1982 Corvette: Service News: Fuel Filter Usage and Installation

Source: Chevrolet Service News

Date: November/December 1982 - Volume 54-6 - Number 12

Part C Shop Manual Updates

Fig. 1 — Fuel Filter

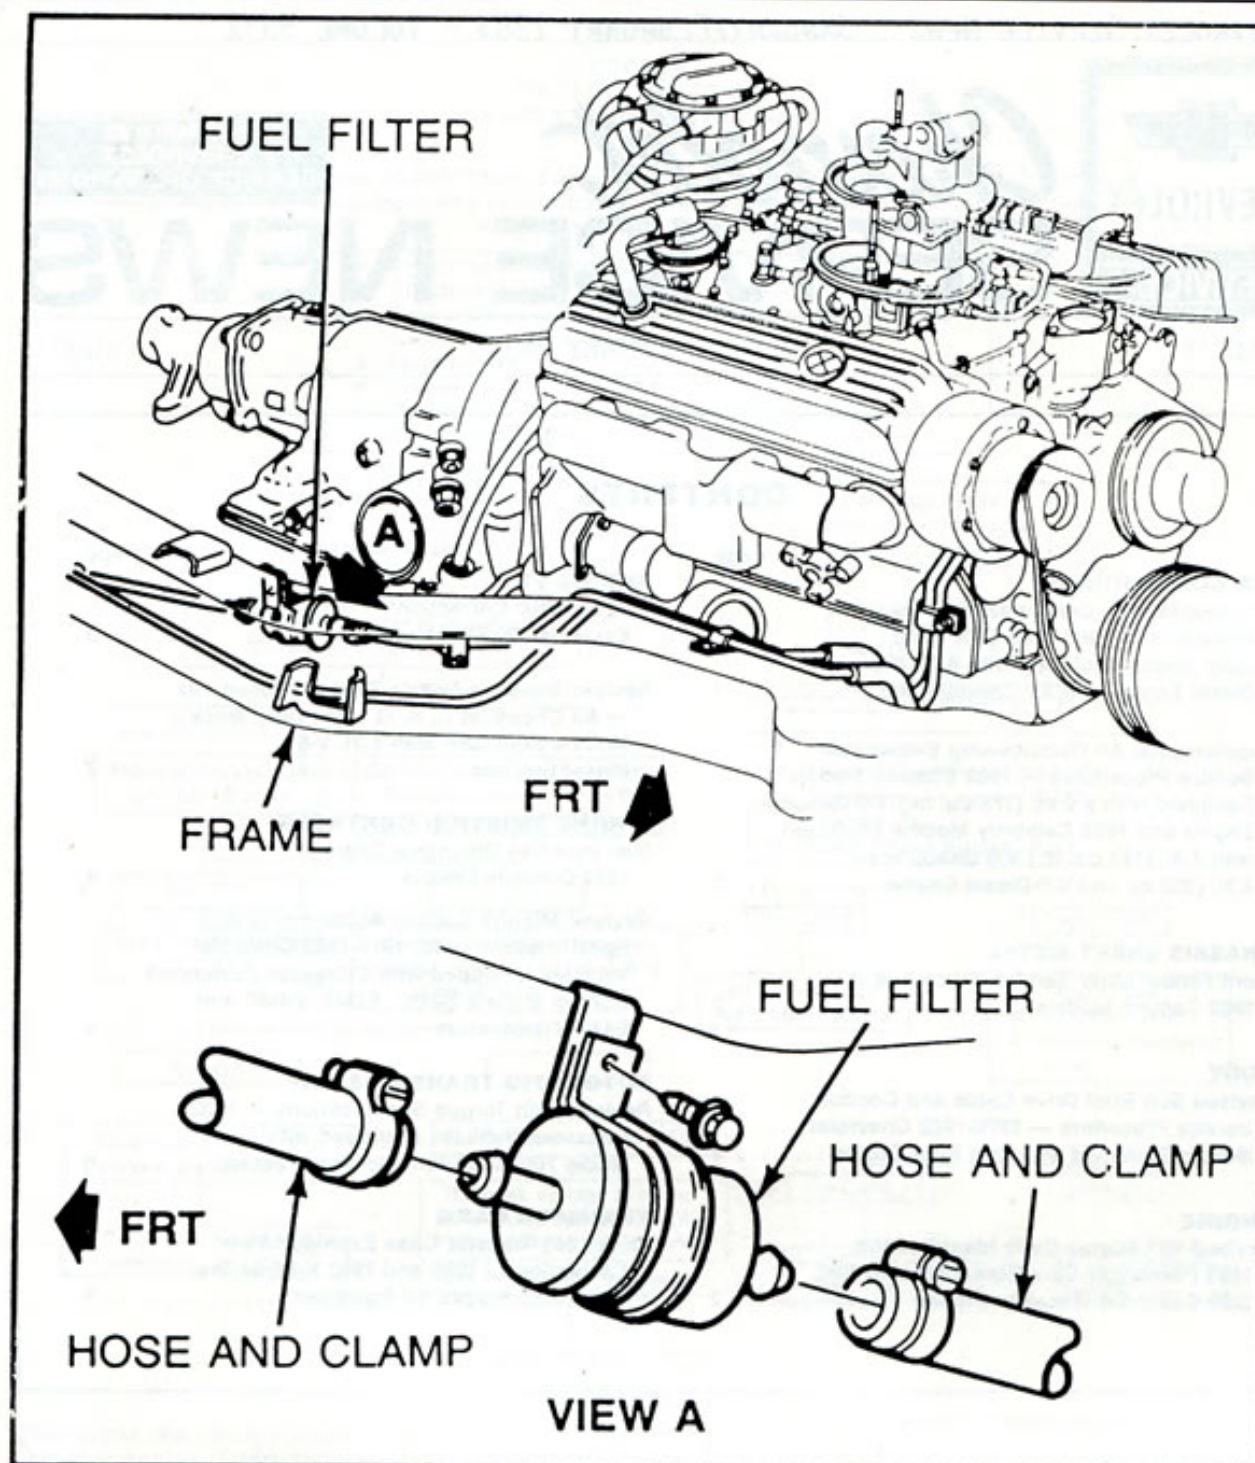
The fuel filter number, GF478, shown on Page 7-2 of the 1982 Corvette Owner's Manual and Figure 6C-3 shown in Section 6C of the 1982 Corvette Shop Manual (ST-364-82) are incorrect. The correct fuel filter number is GF482 and Figure 1 should be used in place of Figure 6C-3 shown in the Corvette Shop Manual.
